MDI interface for 10BASE-T1

IEEE 802.3cg

Long Beach, Jan.2019

Comment 315 and 320

Comment 315 and 320

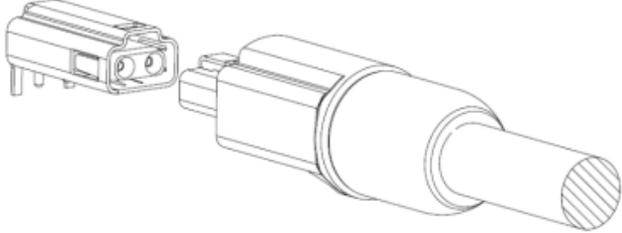
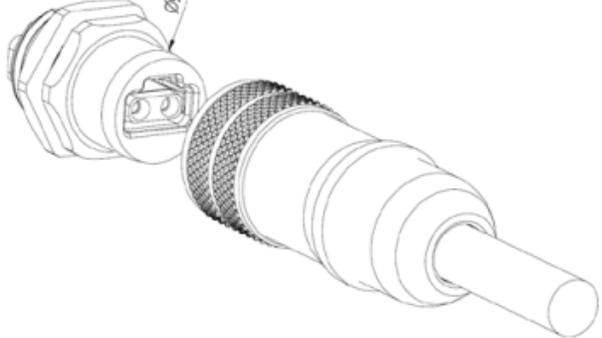
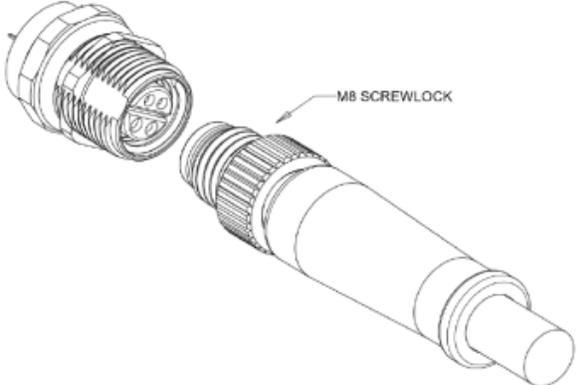
- Different applications need different interface solutions
- Several applications uses pcb terminal blocks instead of connectors
- Cables up to AWG14 are not suitable for the defined connectors
- IEC 63171- series nor IEC 61076-3-125 is suitable for an interface at the device
- Senseless to mention any MDI connector for 10BASE-T1
- Suggest to modify 146.8.1 as follows:

The mechanical interface to the balanced cabling is a 3-pin connector (BI_DA+, BI_DA–, and optional SHIELD) or alternatively a 2-pin connector with an optional additional mechanical shield connection or any other interface which conforms to the link segment specification defined in 146.7.
